ADDENDUM NO. 1

CITY OF BELEN WASTEWATER TREATMENT PLANT BLOWER ADDITION RFP NO. 2013-2

The following Addendum shall be incorporated into the Contract Documents for the referenced project.

BLOWER NO. 4 (MOTOR 205) SCHEMATIC
SCALE: NONE

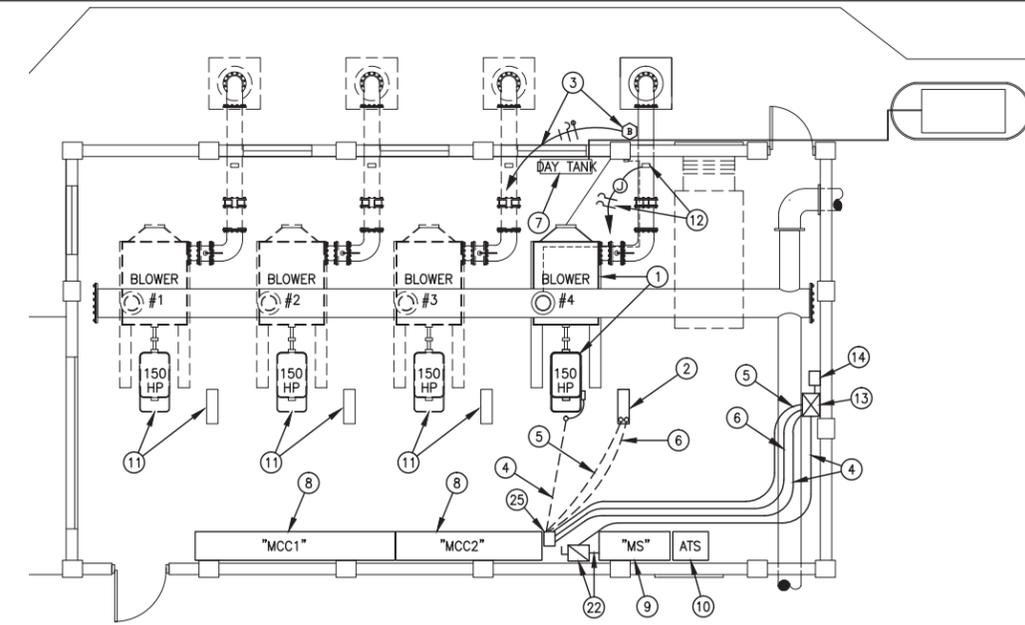
3. Sheet E-101 and Sheet E-201; A revised Sheets E-101 and E-201 are attached herein, replacing the original sheets.
4. Sheet E-101; Keyed Notes 5 and 6: All exposed conduit to be IMC minimum.

POWER PLAN
SCALE: 3/16"=1'-0"

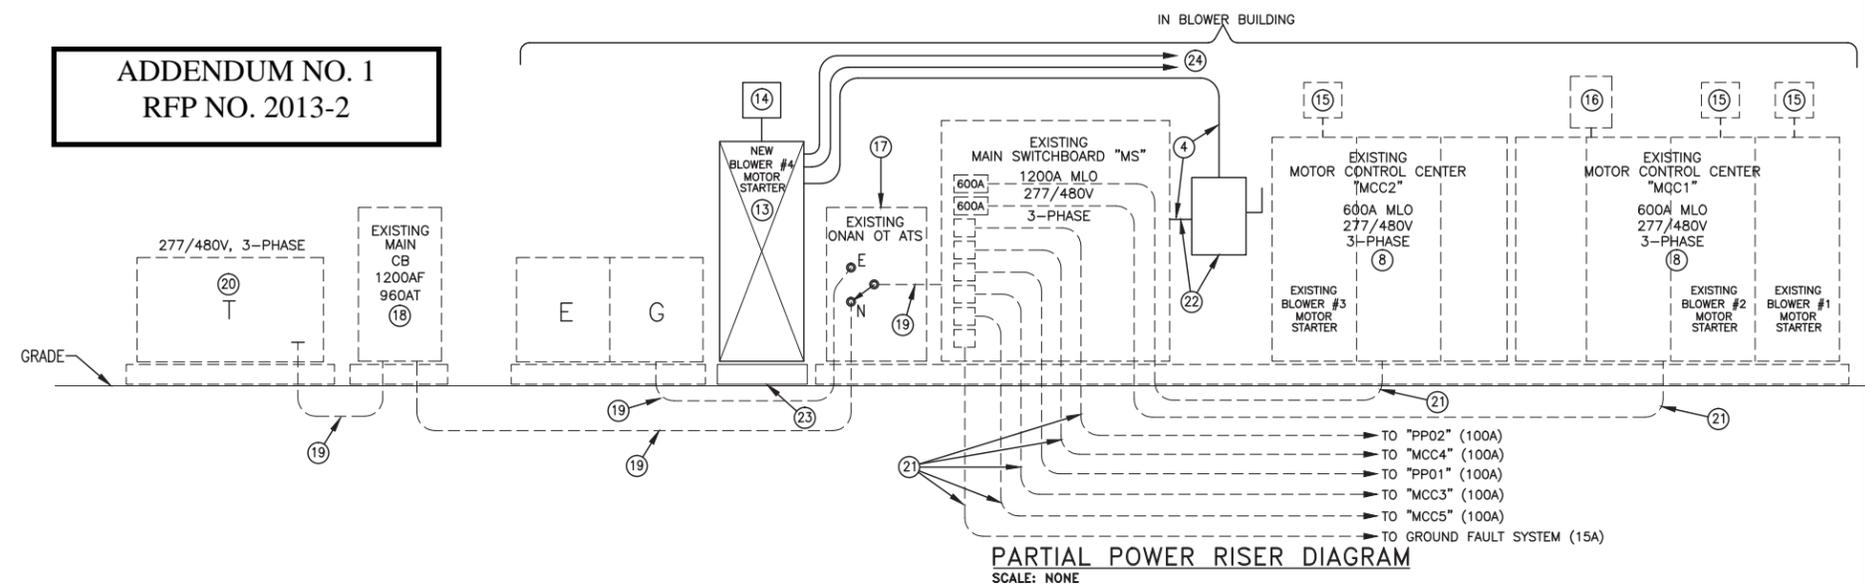
5. Sheet E-101; Keyed Note No. 23: Provide gray epoxy polyamide coating to match existing floor coating for new concrete maintenance pad at new stand-alone starter (Sheet E-101; Keyed Note No. 23).
